DOCUMENT CHANGE REQUEST

DCR number 117

Title: Resistors Heaters Flexible Single and Double Layer, Follow-up Specification for ESA/SCC Detail

Number: 4009/002

PHYSICAL DIMENSIONS AND HEATER OUTLINE

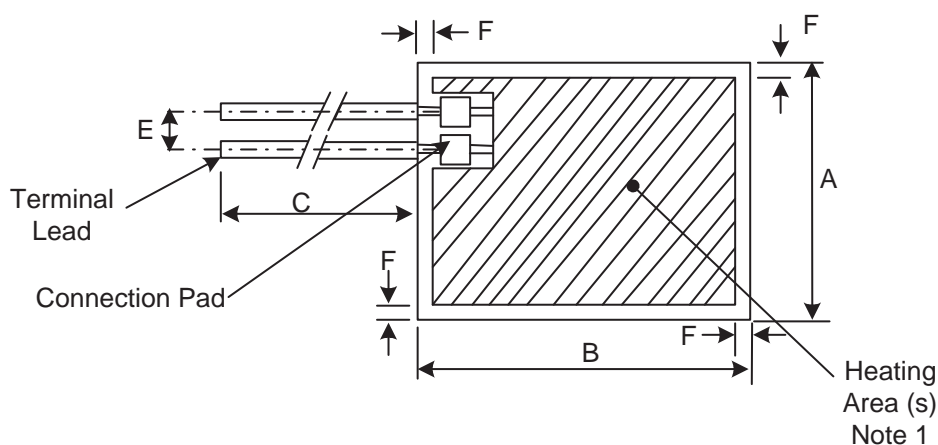
5) Delete dimension 'D' requirement and add notes to Figure 2 to allow terminal leads to exit the terminal connection area at any angle, plus define the lead spacing (Dim. 'E') to be measured at the terminal connection area. The position of the connection pads, and hence leads, is now only limited by the peripheral margin (Dim. 'F'). The new RICA/Nicolitch lead attachment process allows more flexibility in the positioning and aspect of the terminal leads whilst maintaining mechanical and material integrity.

2. The tolerance shall be $\pm 10\%$ on the required dimension.
3. The tolerance shall be $\pm 0.5\text{mm}$ on the required dimension.
4. Terminal lead spacing shall be measured at the terminal connection area. Terminal leads may exit the terminal connection area at any angle. The terminal leads may be located on any side of the heater. There may be more than 2 terminal leads (for multiple resistive element and double layer heaters).
5. Peripheral margin dimension of the finished product.
6. Perforated holes in the peripheral margin are allowed provided that the distance between the edge of hole and the heater element or connection pad is equal to, or greater than, dimension F.
